Docket Item #6
BAR CASE# 2005-00078

BAR Meeting
July 27, 2005

ISSUE: Addition and alterations

LOCATION: 227 North West Street

Figure 1 - Rear elevation

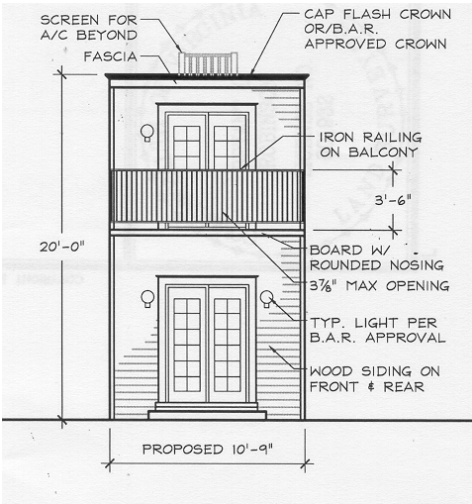
Rear Addition - A two story, flat roofed addition is proposed for the rear elevation. The addition will be 15'9" long, 10'9" wide and 20' high. The addition is smaller than the existing main block. It will extend several feet beyond the rear wall of one story addition to the north and will be roughly equal in length to the house to the south. It will be no higher than the existing house at the rear and 2 ½' lower than the house at the front. The addition will be 1'5" narrower than the existing house to avoid building on the area of deed overlap along the south property line and to assure that all drainage occurs on the subject property. Both side walls will be blind. The rear elevation has a pair of multi-light doors centered in the first and second stories. The doors will be wood doors with simulated divided lights manufactured by Kolbe and Kolbe. The second story will have a balcony across the full width of the addition. As drawn, the balcony has a simple railing with straight pickets. There will be two light fixtures on either side of the first story door and a single fixture beside the second story door. A cut sheet of the exterior light fixtures provided by the applicant shows a traditional lantern style fixture with a polished brass finish. Contrary to what is indicated on the drawings, the applicant has stated that the all sides of the addition will be clad with wood lap siding. The roof of the addition will be clad in single ply membrane and will not be visible. An HVAC unit will be located on the roof of the addition, close to the end of the existing house. The unit will be screened by a 24" high wood fence with 4 x 4 posts at the corners and 3" pickets with a 1" spacing. The applicant has affirmed the siding, doors, trim and HVAC screening will be painted.

Figure 2 - North elevation

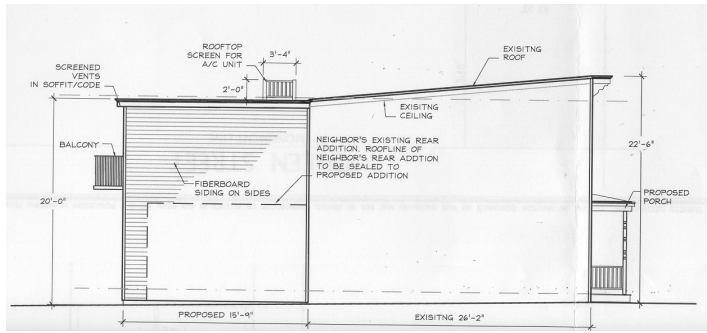
The proposed addition will abut and capulate the south wall of the 229 North West Street, the house to the north. There are two existing windows in that wall. The applicant is working with Code Enforcement and the owner of the neighboring property to resolve issues related to this matter. It is not anticipated that this process will result in any alteration in the plans. However, if there is a significant alteration, the applicant must resubmit to the BAR for review and approval.

- F-1 The proposed project impacts on existing window openings for the adjacent property on the north interior lot line. The applicant shall meet with Code Enforcement Engineering section to resolve this conflict.

Figure 4 - Front elevation

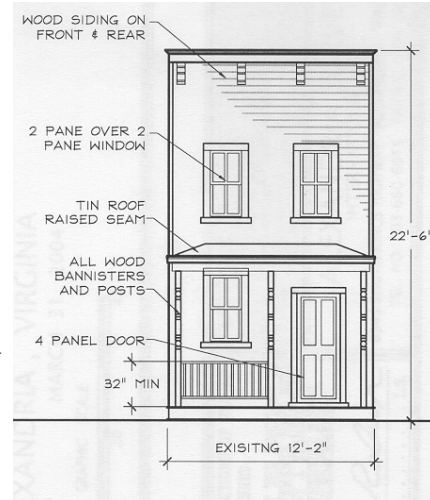
The existing house will be renovated and a new front porch will be added. The asphalt siding will be removed and replaced with wood lap siding. The existing non-historic front windows will be replaced with new Kolbe and Kolbe wood windows with a two-over-two configuration. The applicant has stated that the front windows will have true divided lights. The existing non-historic front door will be replaced with a new four panel wood door. Although not shown on the drawing, the applicant has confirmed that there will be an exterior light fixture beside the front door. The fixture will be the same brass lantern as used on the rear addition. Although the drawing shows the first story window raised above the top of the adjacent door, the applicant has confirmed to Staff that the existing window and door locations on the front elevation will be unchanged. Similarly, the applicant has confirmed that the existing historic cornice will be retained as is and that the drawing was not intended to depict any alteration to that feature. The meter box located on the front of the house will be moved to the side and recessed.

The new, one story porch will extend nearly the full width of the front of the house and project 4' from the front of the house. Although not shown on the drawings, the applicant has confirmed that the porch will be held back 6" on either end so as not to encroach on the deed overlap on the south side of the property. According to the applicant, the porch will have a brick foundation with wood flooring. It will have a hip roof covered in standing seam metal and supported by turned wood posts. The railing will be a simple wood railing with straight pickets. The applicant has affirmed that the new siding, windows, door, trim and wood porch will be painted.
